Office Action Summary	Application No. 10/711,326	Applicant(s) NAKANO ET AL.	
	Examiner THOMAS IRVIN	Art Unit 3657

DETAILED ACTION

Claims 13, 14, and 18 are rejected under 35 U.S.C. 102(b) as being anticipated by Militana (3,168,836).

Fig. 4 (US 3,168,836)

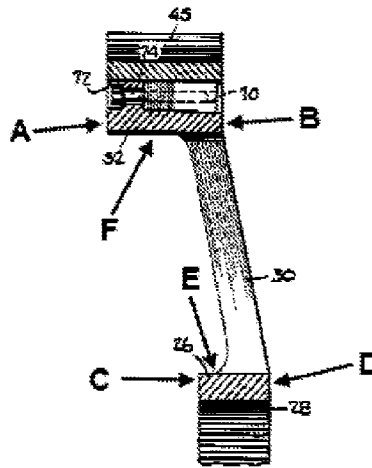
In Re claim 13, Militana discloses, with reference to fig. 4 above, a sprocket comprising: a sprocket body (20); a plurality of teeth (45); a radially inwardly and outwardly extending spline (28), wherein the spline has a root portion (30) and a radially inner portion (26) having a side wall (C,D); wherein the spline terminates at a free end (26); and wherein a thickness of the radially inner portion (26) is greater than a thickness of the root portion (30). Examiner notes that the radially inwardly extending spline and radially outwardly extending spline are understood to be the protrusions and corresponding depressions of the spline.

In Re claim 14, see side wall (A), first side wall portion (24), teeth (45), and root portion (32).

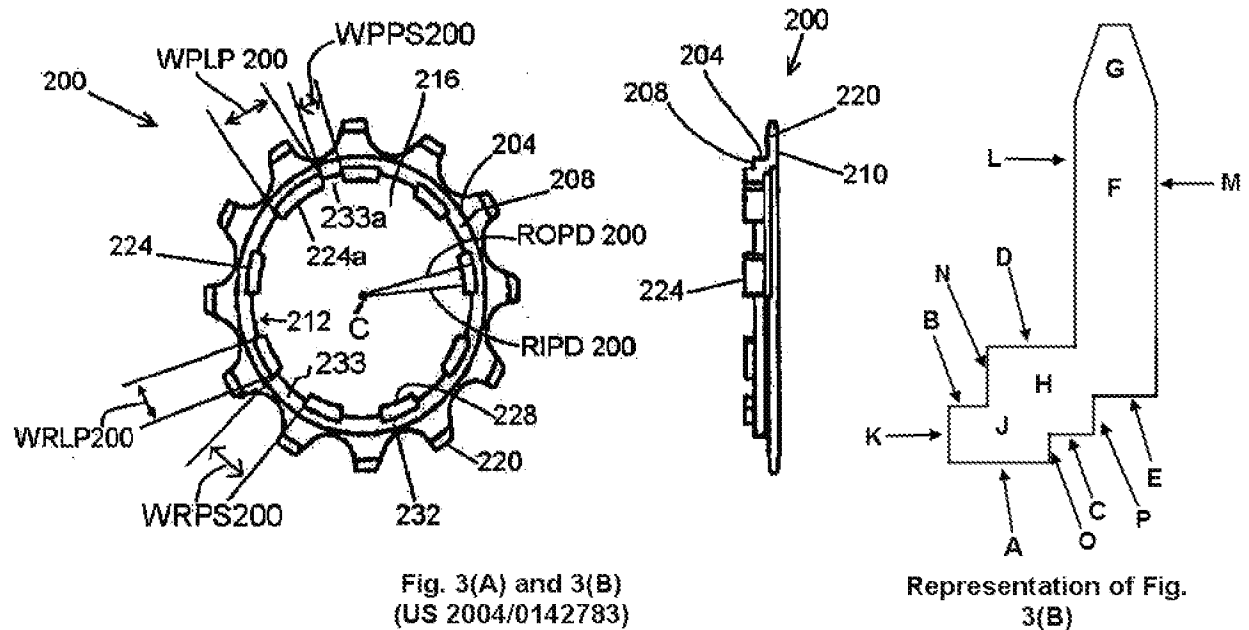
In Re claim 13, Kamada et al. disclose, with reference to figs. 3A and 3B above, a sprocket comprising: a sprocket body (200,F); a plurality of teeth (G); a radially inwardly and outwardly extending spline (A, C), wherein the spline has a root portion (H) having side walls (N,P) and a radially inner portion (J) having side walls (K, O); wherein the spline terminates at a free end (K); and wherein a thickness of the radially inner portion (J, K-O) is greater than a thickness of the root portion (H, N-O). Examiner notes that the radially inwardly extending spline and radially outwardly extending spline are understood to be the protrusions and corresponding depressions of the spline.

In Re claim 14, the sprocket has a side wall (M) and first side wall portion (F), wherein the plurality of teeth (G) extend from the first side wall portion, and wherein a

thickness of the first side wall portion (L-M) substantially equals a thickness of the root portion (H, N-L, L-M).

In response to applicant’s arguments regarding the 102(e) rejection to Kamada et al., the examiner has now attempted to clarify the rejection by additionally identifying the side walls (N,P) of the root portion.
